Liveable Neighbourhoods Zone 04 - Catharine Place

Stage 3 Road Safety Audit

Bath and North East Somerset Council

Project number: 60668625

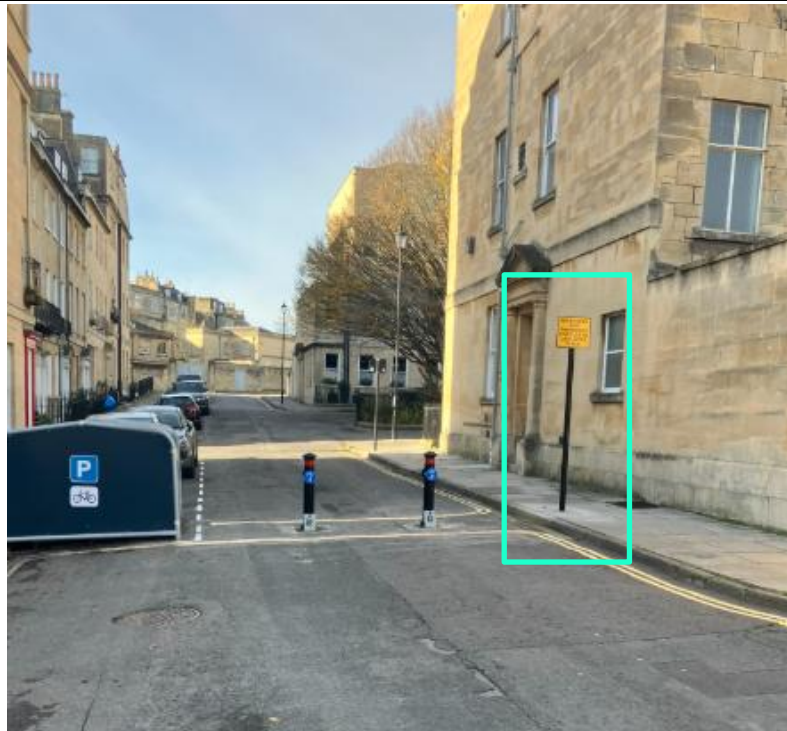
Problem: E1.1	
Drawing Number(s):	60668625-ACM-04-DD-LL_ETRO-SHT-0103.
Location:	Catharine Place (adjacent to Rivers Street Mews).
Summary:	Location of “no access” warning sign may result in drivers undertaking sudden and unsuitable manoeuvres, leading to graze type or rear end shunt collisions.

Description:

A “no access” sign has been installed as part of the scheme, to inform westbound drivers that access cannot be gained to Catharine Place from Circus Mews. However, the sign is located next to the bollards which prevent this movement rather than providing an advanced warning. This may result in drivers undertaking sudden manoeuvres or unsuitable turns in the road upon realising that access cannot be gained to Catharine Place, causing graze type or rear end shunt collisions.

Recommendation:

It is recommended that the sign is relocated and positioned before the bollards.

Road Safety Audit Stage 3 Designers Response:

Disagree with the recommendation.

The sign and bollards can be seen from both directions. There is opportunity to divert around the bollards, using either Rivers Street or Catharine Place.

The information sign was designed with a 40mm x height due to the historically sensitive nature of the area. It is a temporary sign and is due for removal at the end of the ETRO trial period.

Road Safety Audit Stage 3 Overseeing Organisation Response:

Disagree with the recommendation for the reasons outlined in the Designer's response.
